গণপ্রজাতন্ত্রী বাংলাদেশ সরকার  
শ্রম ও কর্মসংস্থান মন্ত্রণালয়  
কলকারখানা ও প্রতিষ্ঠান পরিদর্শন অধিদপ্তর

ক্যাপ পর্যবেক্ষণের তথ্য

কারখানার নাম	এ আর আর ডিসেমোটিক্স
ঠিকানা	3, NO, MADRASA BAZAR ROAD, MATUAIL, JATRABARI, DEMRA, DHAKA
কারখানার কোড	DHK007
কালার কোড	
মূল্যায়নের ধরণ: <b>বৈদ্যুতিক মূল্যায়ন</b>	পর্যবেক্ষণের তারিখ: ০৫-০৪-২০২৩
১. পর্যবেক্ষণ

সংযুক্তিসমূহ (৮)

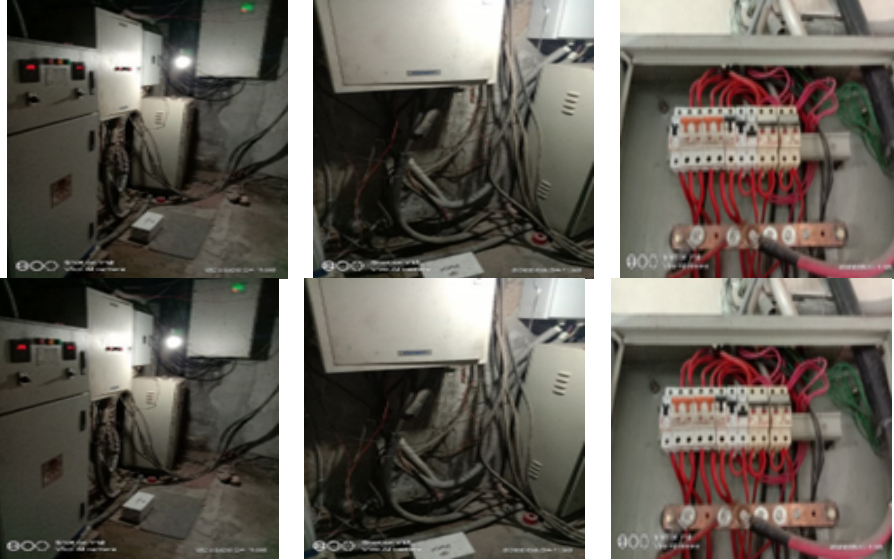
পরিদর্শন পর্যবেক্ষণ	MDB Panel door damaged/not present ☐ No instruction for first aid to electrical shock ☐ No clear identification mark on distribution board ☐ Access obstructed/barred ☐ Cable ends not properly soldered or crimped ☐ Connection without lug ☐ Messy wire inside ☐ MDB installed on the wooden board
ক্যাপ আইটেম ক্যাটাগরি

কার্যক্রম	Provide instructions for first aid from exposure to electrical shock ☐ Remove obstruction to ensure access to MDB/MCB Box ☐ Ensure well-dressed cabling with lugs ☐ Ensure proper door & properly enclose MDB panel.
সুপারিশের ভিত্তিসূত্র	
কারখানার কার্যক্রম	
অগ্রাধিকার	প্রযোজ্য নয়
চূড়ান্ত সময়সীমা	-
সংশোধিত সময়সীমা	-
অগ্রগতির অবস্থা	চলমান
মন্তব্য	19-10-2020: 1. No instruction boards for first aid and artificial respiratory system. 2. No obstruction observed for the distribution boards. 3. Electrical cables were found to be messy and terminated without proper sized lugs inside the distribution boards. 4. Distribution boards were found to have proper enclosure. 06-01-2020: On visit day MDB Panel door damaged not present. No instruction for first aid to electrical shock, No clear identification mark on distribution board, Access obstructed / barred, Cable ends not properly soldered or crimped, Connection without lug, Messy wire inside, MDB installed on the wooden board. 06/05/2021: 1. No instruction boards for first aid and artificial respiratory system. 2. No obstruction observed for the distribution boards. 3. Electrical cables were found to be messy and terminated without proper sized lugs inside the distribution boards. 4. Distribution boards were found to have proper enclosure. 22.08.2021: On visit day, 1. No instruction boards for first aid and artificial respiratory system. 2. No obstruction observed for the distribution boards. 3. Electrical cables were found to be messy and terminated without proper sized lugs inside the distribution boards. 4. Distribution boards were found to have proper enclosure. 04-08-2022: Visit observation, 1. No instruction boards for first aid and artificial respiratory system were found.. 2. Obstruction were observed for the some distribution boards. 3. Messy wire/cable and terminated without proper sized lugs inside the distribution boards were found. 4. Distribution boards were found to have proper enclosure. 05.04.2023: 1. No instruction boards for first aid and artificial respiratory system were found.. 2. Obstruction were observed for the some distribution boards. 3. Messy wire/cable and terminated without proper sized lugs inside the distribution boards were found. 4. Distribution boards were found to have proper enclosure.
